## ALERT SERVICE BULLETIN

**407-24-138**

**MODEL AFFECTED:** 407

**SUBJECT:** ROOF BEAM SHIMMING, INSPECTION AND REPAIR OF

Figure 2: Roof beam potential Gap locations (Sheet 1 of 2)

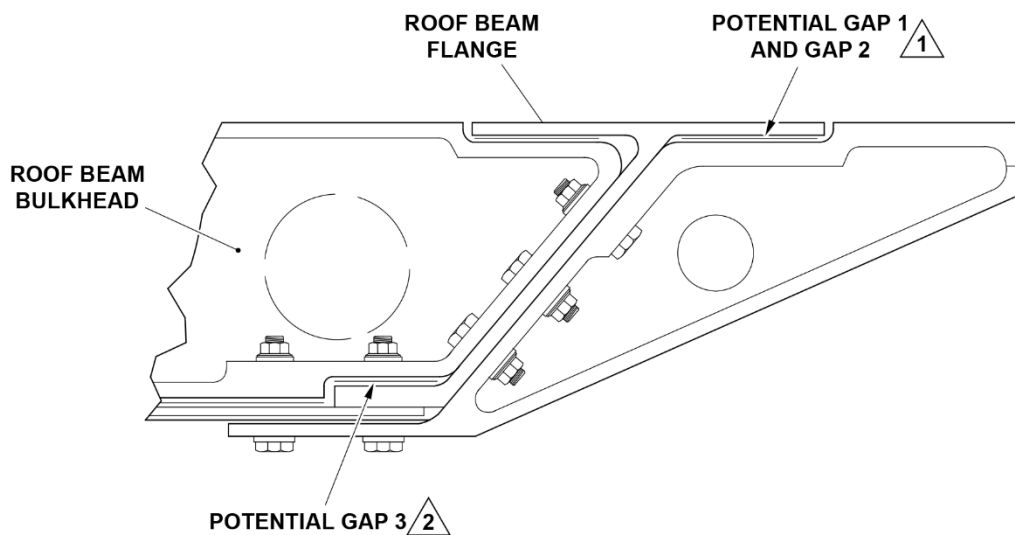
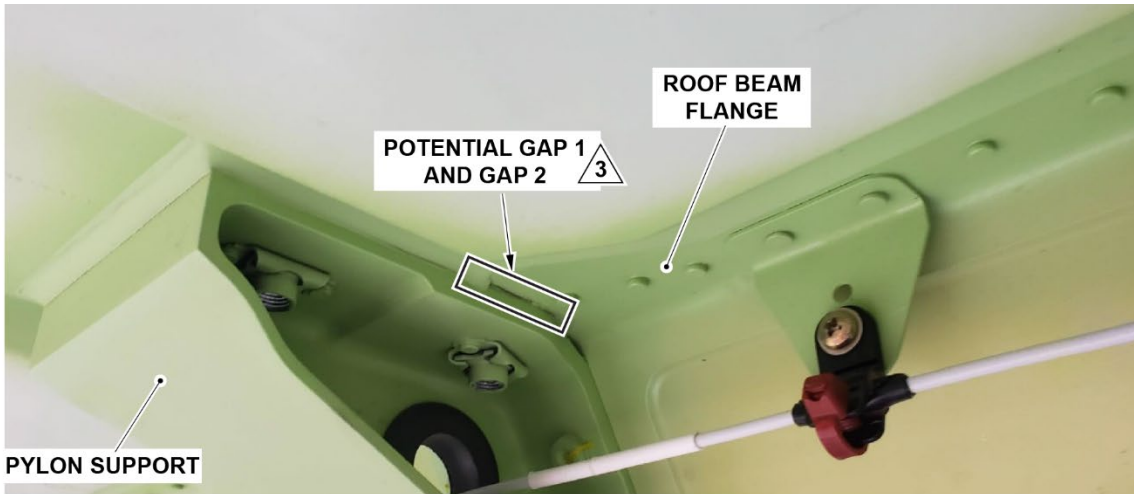
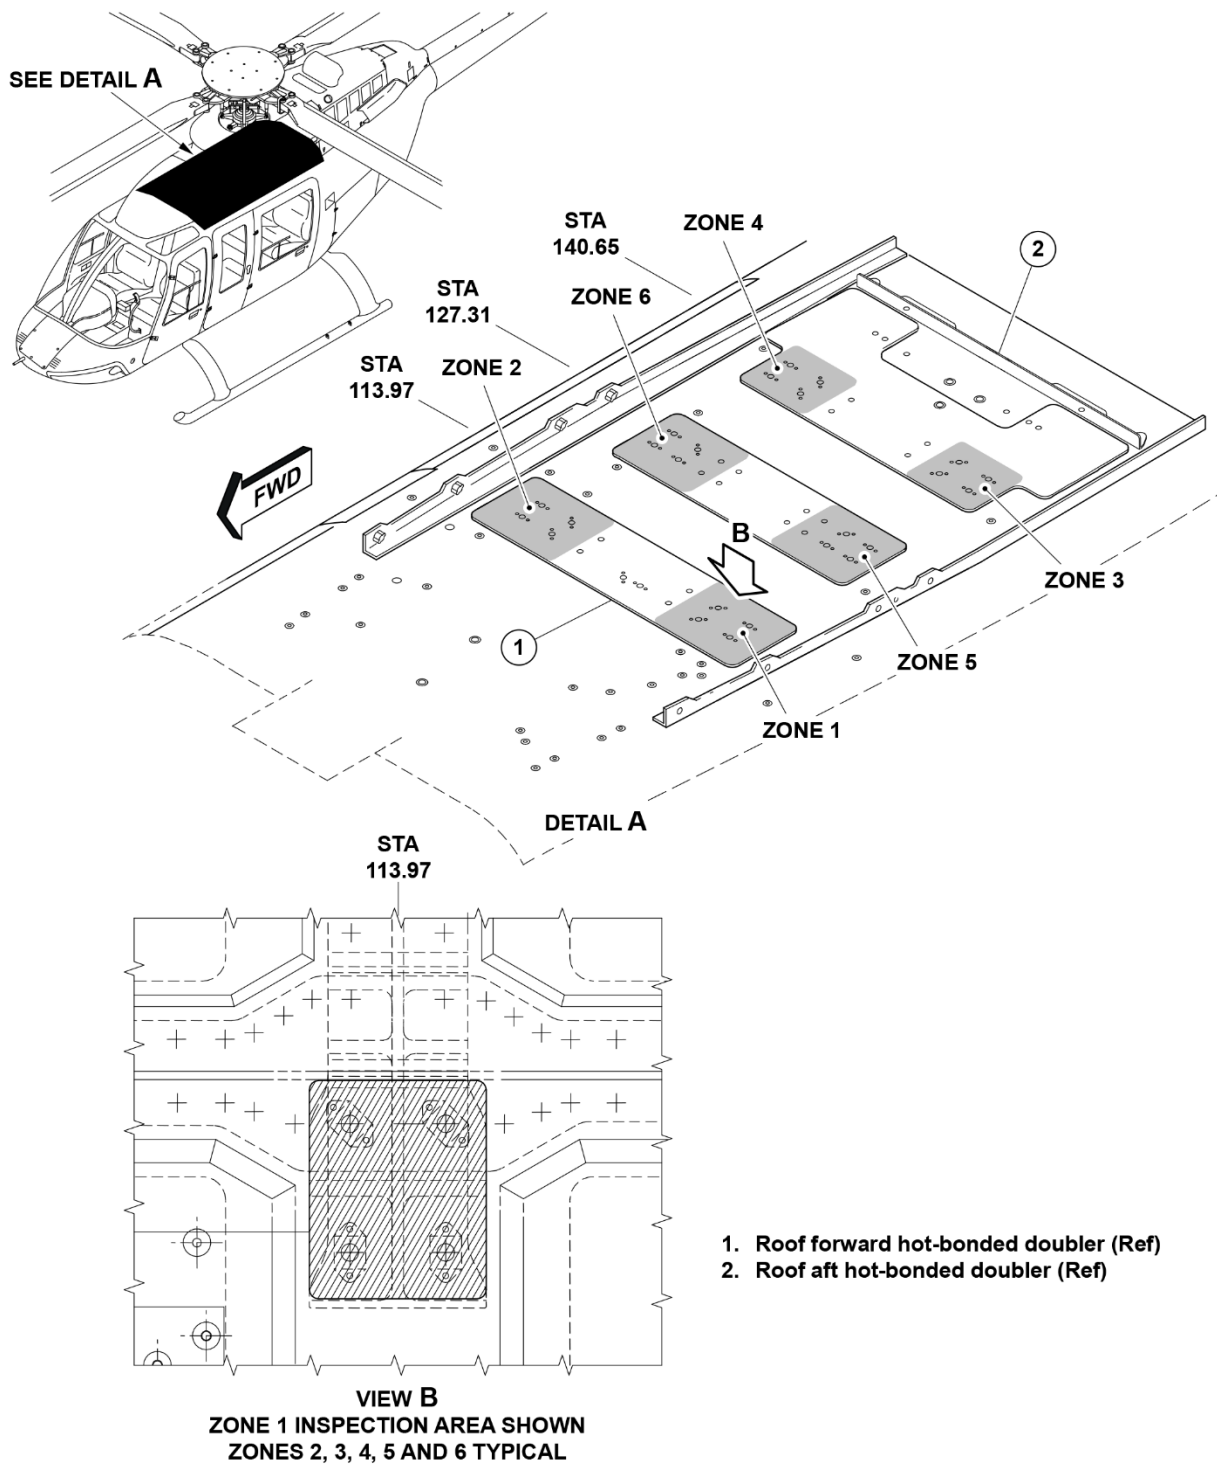
8. Remove sealant at the junction of every pylon / stop support and roof beam outboard flanges (Figure 2).
9. Using a feeler gauge, inspect for gap at the locations specified below. If gaps are found, measure and record them:

- a. At fuselage STA 113.97 and 140.65: Inspect for Gap 1 (fore and aft) between roof beam flange and pylon support (View B and C, Figure 2). Inspect for Gap 3 inside roof beam (both sides) (View D, Figure 2).

- b. At fuselage STA 127.31: Inspect for Gap 2 (fore and aft) between roof beam flange and stop support (View B and C, Figure 2). Inspect for Gap 3 inside roof beam (both sides) (View D, Figure 2).

- c. At fuselage STA 145.40: Inspect for Gap 3 inside roof beam (both sides) (View B and D, Figure 2).
10. Depending on the measured gap(s) values, roof beam shimming will need to be accomplished within different intervals.

- a. At fuselage STA 113.97 and 140.65: Inspect for Gap 1 (fore and aft) between roof beam flange and pylon support (View B and C, Figure 2). Inspect for Gap 3 inside roof beam (both sides) (View D, Figure 2).
- b. At fuselage STA 127.31: Inspect for Gap 2 (fore and aft) between roof beam flange and stop support (View B and C, Figure 2). Inspect for Gap 3 inside roof beam (both sides) (View D, Figure 2).
- c. At fuselage STA 145.40: Inspect for Gap 3 inside roof beam (both sides) (View B and D, Figure 2).

- a. If no gap exceeding 0.003 inch (0.076 mm) is detected, PART II of this ASB is not required. Proceed to step 11.

- b. If any gap exceeding 0.012 inch (0.305 mm) is detected, the affected pylon side beam shall be replaced and PART II of this ASB must be accomplished before next flight.

- c. For gap(s) exceeding 0.003 inch (0.076 mm) and not exceeding 0.012 inch (0.305 mm), PART II of this ASB must be accomplished within 660 flight hours or 12 months whichever occurs first after the release date of this bulletin .

**Figure 3: Roof shell doubler FPI inspection areas**

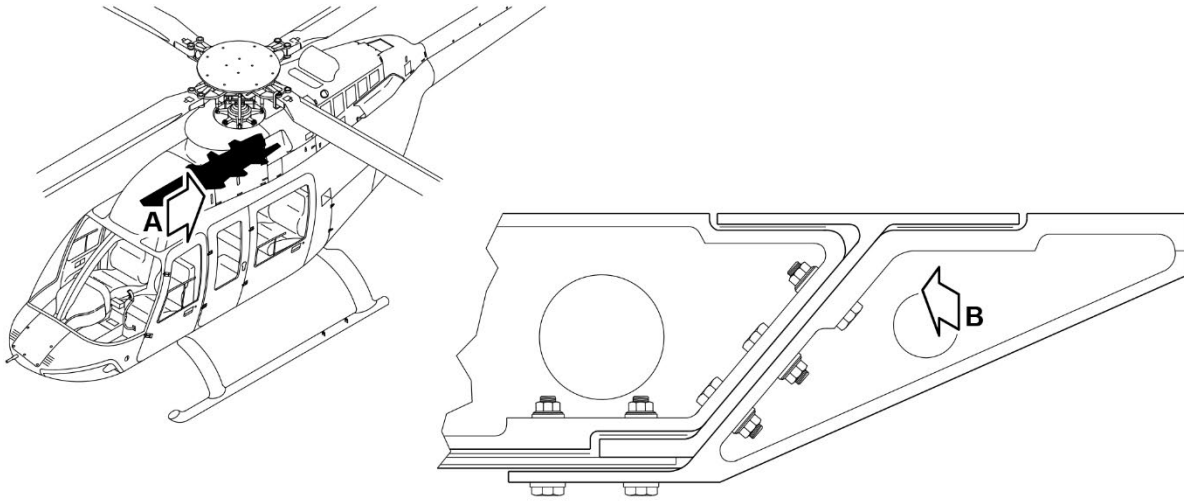
- b. Remove the pylon beam shim or stop fitting shims from the roof shell doublers at the affected zone (where a gap was found on the roof beam) as shown in Figure 3. If not damaged, retain original affected shim.

- c. Remove primer on roof shell doublers in the affected zones (where a gap was found on the roof beam) as shown in Figure 3.
  - d. Perform a Fluorescent Penetrant Inspection (FPI) on the roof shell doublers at the affected pylon beam or stop fitting shim footprint areas (Figure 3). If no crack is found, refinish with primer (C-204) and reinstall affected shim.

- e. If a crack is detected, the roof shell will need to be repaired. Send a duly completed Structural Repair request (Ref: IL GEN-22-154) to Product Support Engineering.

**Figure 4: Pylon support and stop support area to inspect**

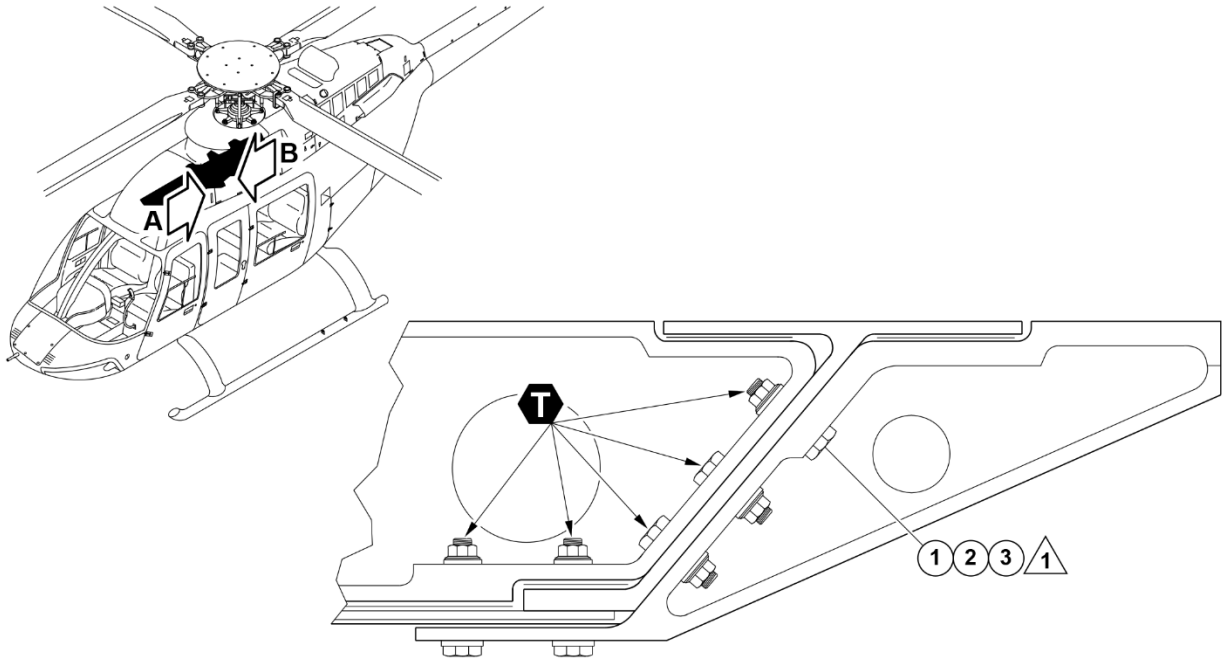
- g. Using a 10X magnifying glass, inspect the affected pylon supports or stop supports within the inboard upper radius. Inspect for any signs of crack (Figure 4).

- j. If a crack is detected, the roof beam assembly will need to be replaced in a Bell Approved fuselage fixture. Report any crack to Product Support Engineering.

**Figure 5: Installation of pylon and stop supports**

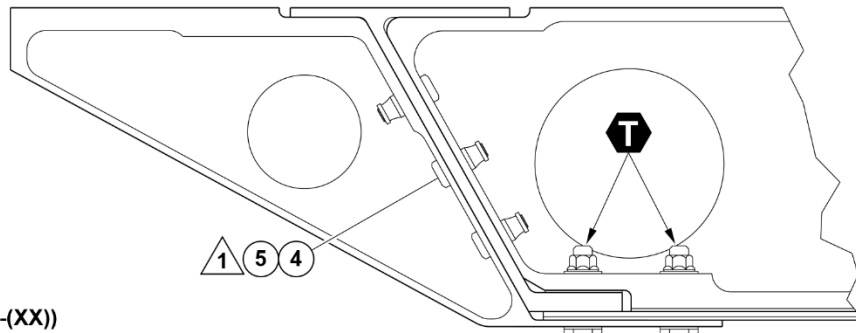
- d. Install the pylon support or stop support to the roof beam using the removed hardware (Figure 5). Install the four outboard pylon beam or stop fitting bolts through the roof shell by hand.
- e. Torque the hardware removed from the roof beam (Figure 5).

- a. Remove and retain bolt (1, Figure 5) or pin (applicable only at STA 145.40) at the location where a gap is detected. Confirm the gap with the affected bolt or pin removed does not exceed 0.008 inch (0.203 mm).
- b. Remove loose material / adhesive between parts using shop air.

- f. Clean bolt (1) or pin. Install and torque as shown in Figure 5.
- 12. Clean pylon or stop support bolt threads.
  - 13. Install the transmission assembly with the mast, swashplate and pylon beam assembly (DMC-407-A-63-21-00-00A-720A-A).
  - 14. Install air inlet cowling assembly (DMC-407-A-53-04-00-02A-720A-A) and transmission fairing assembly (DMC-407-A-53-04-00-01A-720A-A).
  - 15. Install the center passenger headliner (DMC-407-A-25-20-00-04A -720A-A).
  - 16. Make an entry in the helicopter logbook and historical service records indicating compliance with PART II of this Alert Service Bulletin.
